Office Action Summary

10/632,394

PAVLOV, MICHAEL V.

GB-2,039,683

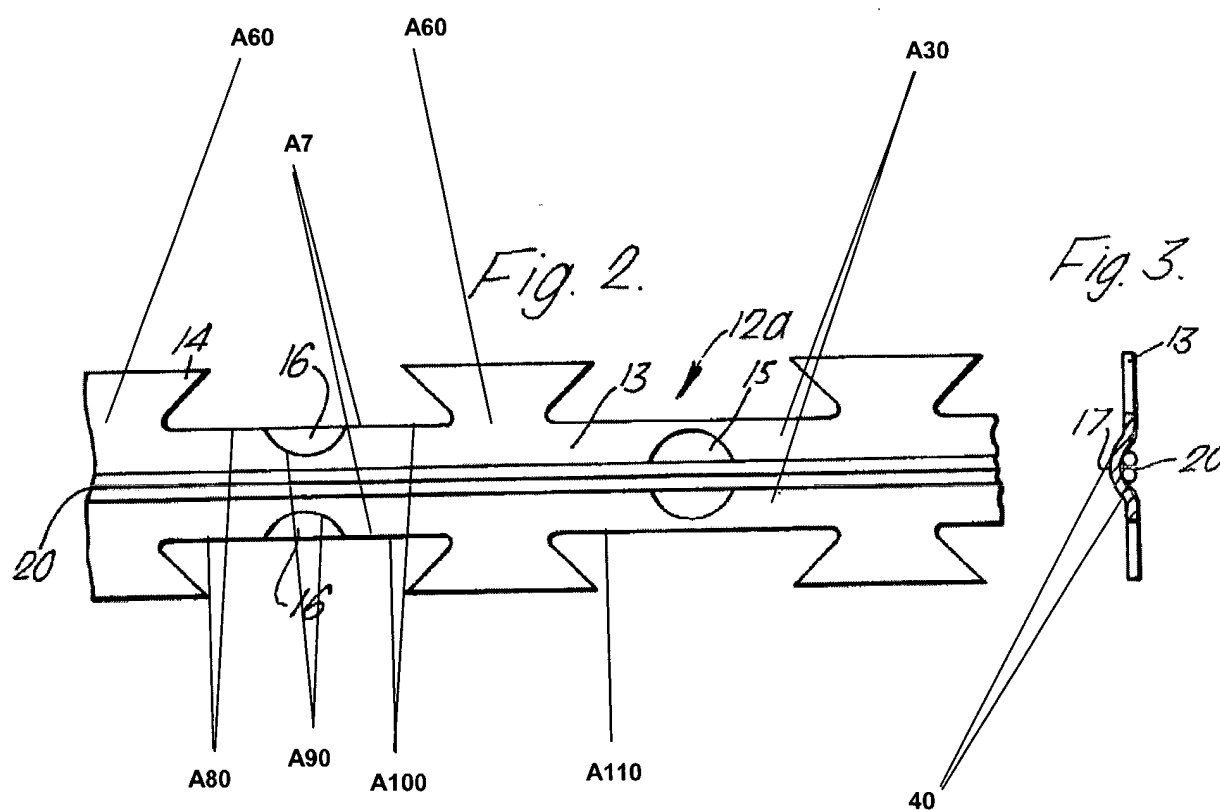
Claims 31, 32, 34 and 35 are rejected under 35 U.S.C. 102(b) as being anticipated by Fibun, British patent GB-2,039,683 (see marked-up attachment).

Regarding claim 31, Fibun discloses in Figures 2 and 3, a barrier structure comprising a metal tape **12a** comprising an elongate body **13**, a pair of elongate flanges **A30**, and barbs **14**. The body **13** defines a longitudinally extending channel **17**. The flanges **A30** extend transversely from each side **A40** of the channel **17**. The barbs **14** are spaced along the metal tape **12a** and connected to the metal tape **12a** by respective

barb roots **A60**. The flanges **A30** have respective edges **A7** with first edge portions **A80**, second edge portions **A90**, and third edge portions **A100**. The first edge portions **A80** are adjacent to the barbs **14**. The second edge portions **A90** are adjacent to the first edge portions **A80**, and the third edge portions **A100** are adjacent to the second edge portions **A90**. The second edge portions **A90** are recessed inwardly toward the channel **17** relative to the first edge portions **A80** and the third edge portions **A100**. The second edge portions **A90** are not continuous with the first edge portions **A80** or the third edge portions **A100**.

Regarding claim 32, the first edge portions **A80** are longitudinally aligned with adjacent third edge portions **A110**.

Regarding claim 34, the channel **17** does not receive a reinforcing wire (page 2, lines 34-37; a fibre-optic filament is not a reinforcing wire).

Regarding claim 35, the channel **17** forms an arc extending between the flanges **A30**. The arc has an angle of approximately 180 degrees.

Regarding claim 38, Fibun discloses, in Figure 2, a barrier structure comprising a piece of elongated metal tape **12a** comprising an elongate body, barb roots **A60**, a first region **A800**, a second region **A900**, and a third region **A1000**. The body defines a longitudinally extending channel **17** and an elongate flange **A30** extending transversely from each side of the channel **17**. The roots **A60** are spaced along the tape **12a** and secured to each flange **A30**. A pair of tapered barbs **14** are secured to a barb root **A1**. The first region **A800** is adjacent to the barb root **A1**. The second region **A900** is adjacent to the first region **A800** distal from the barb root **A1**. The third region **A1000** is adjacent to the second region **A900** distal from the first region **A800**. The third region **A1000** extends lengthwise from the second region **A900**. The second region **A900** comprises an arcuate cutout **19**. The channel **17** does not receive a reinforcing wire (page 2, lines 34-37; a fibre-optic filament is not a reinforcing wire) and the channel **17** describes an arc extending between each flange **A30**. The arc extends about 180 degrees. However, the third region **A1000** does not meet a corresponding third region extending lengthwise away from another second region.

Applicant is reminded that due to a duplication of the arcuate cutout **19** in a region that includes the first region **A800**, the second region **A900**, and the third region **A1000**, will result a modification as shown in the attachment provided herein, to further weaken the tape (page 2, lines 19-24). Thus, the tape will have more regions and especially corresponding regions as shown in the attachment. As a result, the third region **A1000** meets a corresponding third region **1100** extending lengthwise away from another second region **A1200**. Therefore, it would have been obvious to one having ordinary skill in the art at the time the invention was made to include a second cutout to further weaken the tape. As a result, the third region meets a corresponding third region. *St. Regis Paper Co. v. Bemis Co.*, 193 USPQ 8.
